REMARKS/ARGUMENTS

Amendments to the Drawings:

Annotated Sheet Showing Changes

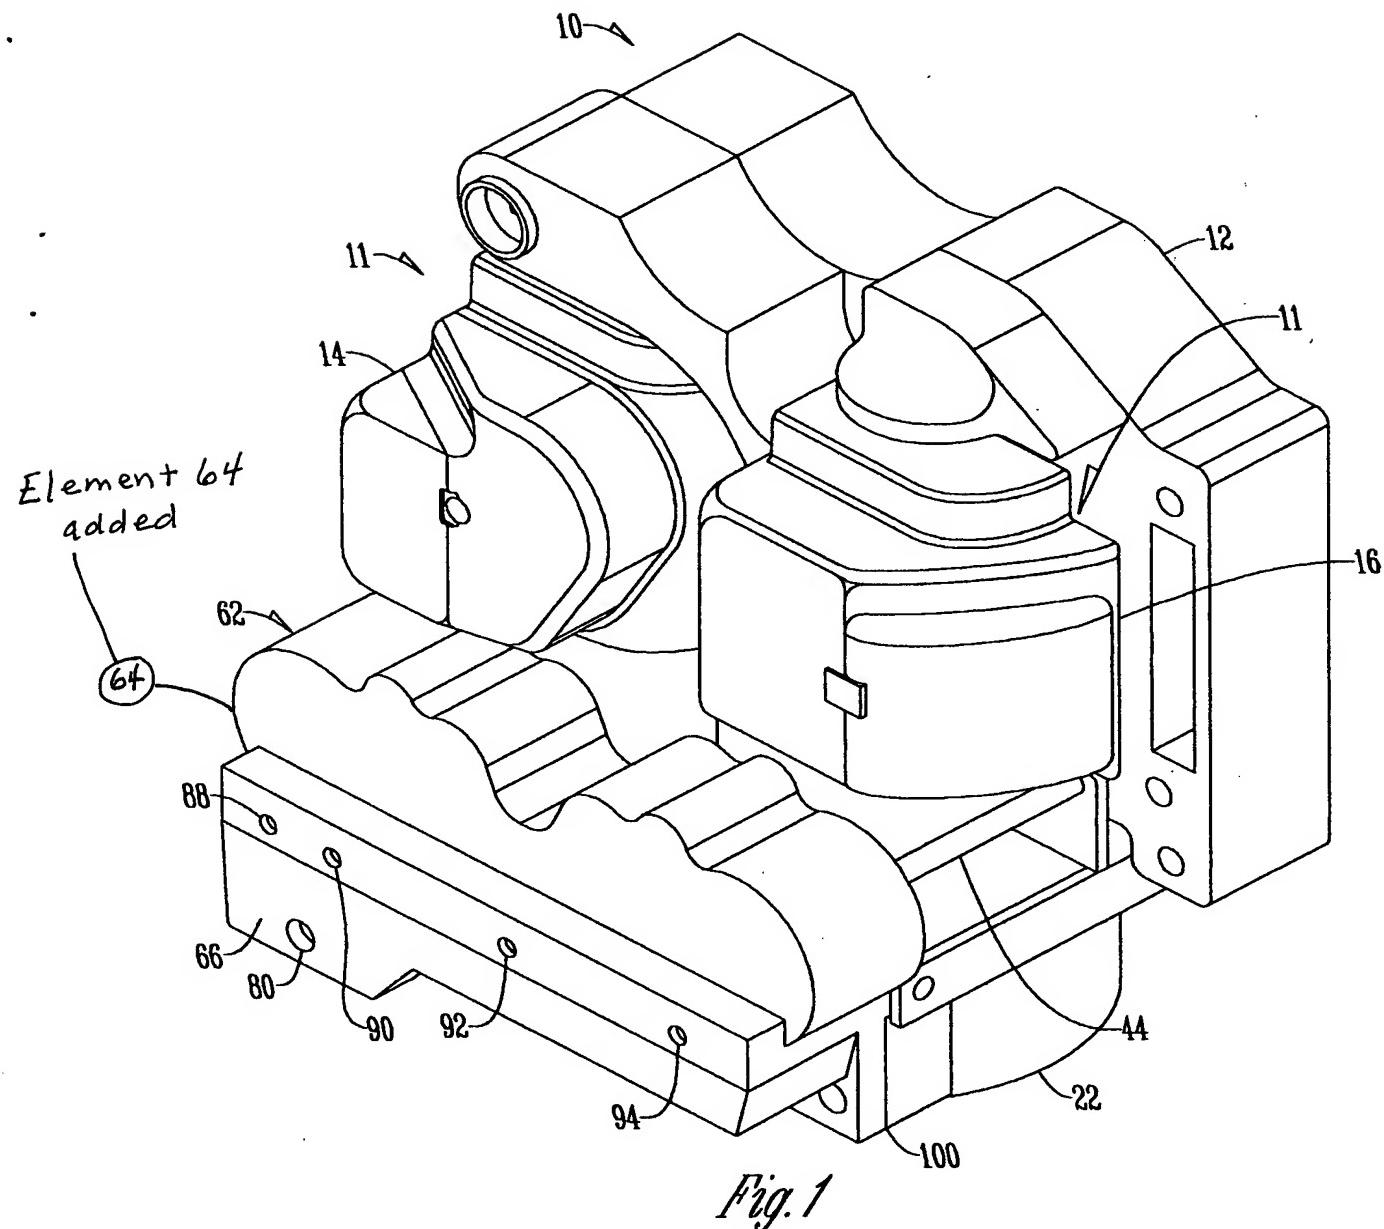
Claims 1-35 are pending in the present application. Claims 29-32 and 35 are allowed. The drawings are objected to as failing to comply with 37 C.F.R. 1.84(p)(5) because they do not include a reference sign in Figs. 1 and 3. Figs. 1 and 3 have been amended in compliance with 37 C.F.R. 1.121(d) and replacement sheets are provided. Claims 1-8, 24 and 25 have been rejected under 35 U.S.C. § 112, second paragraph, as being indefinite for failing to particularly point out and distinctly claim the subject matter which Applicant regards as the invention. Claims 9-13 have been rejected under 35 U.S.C. § 102(b) as being anticipated by Dowty (U.S. Pat. No. 3,163,987). Claims 4, 5, 9, 10, 17, 18, and 33 are rejected under 35 U.S.C. § 102(b) as being anticipated by Folsom (U.S. Pat. No. 6,530,855). Claim 11 has been rejected under 35 U.S.C. § 103 as being unpatentable over Folsom. Claims 1, 8, 16, 20-22 and 27 are rejected under 35 U.S.C. § 103 as being unpatentable over Folsom in view of Moya (U.S. Pat. No. 6,279,452). Claims 12-15, 19, 23, 26, 28, and 34 are objected to as being dependent upon a rejected base claim, but would be allowable if rewritten in independent form including all of the limitations of the base claim and any intervening claims. Claims 2, 6, 7, 24, and 25 would be allowable if rewritten to overcome the 35 U.S.C. § 112, second paragraph, rejections and were rewritten in independent form. Applicant respectfully traverses all rejections.

The attached sheets of drawings include changes to Figs. 1 and 3. These sheets, which include Figs. 1 and 3, replace the original sheets including Figs. 1 and 3. In Figs. 1 and 3, previously omitted element 64 has been added.
